Response Statement by John Duthie - Planning

DATE: 27 July 2021

Response to comments received to the Wooing Tree COVID-19 Recovery (Fast-Track Consenting) Act 2020 – Application by Wooing Tree Property Development LP

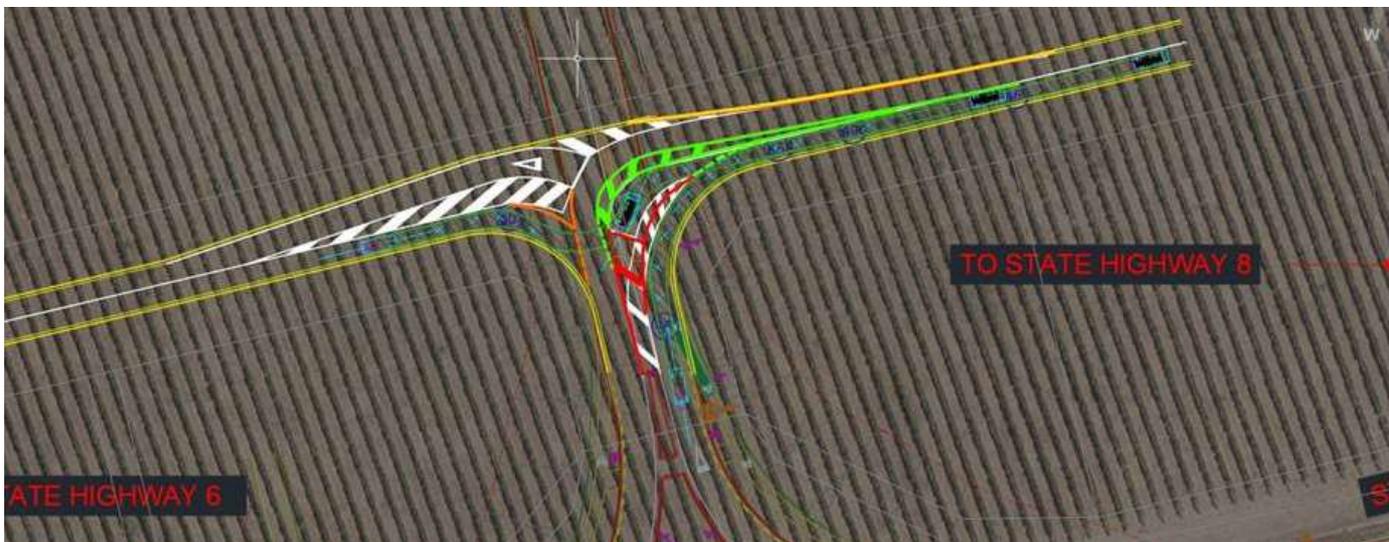
- 137. The bund provides a much higher amenity to the site than would, say, a 1.8m solid fence. External travellers on the State Highway and any pedestrian/cyclists will see the bunds and the vines. Residents within the development on land adjacent to the State Highways will benefit from the planted slope of the bund rather than a solid fence.

138. From a planning perspective, I have proposed conditions of consent which require the construction of the bund and give assurance that the package of the new depth of bund, but with the landscape buffer, will be implemented. These conditions are set out below:
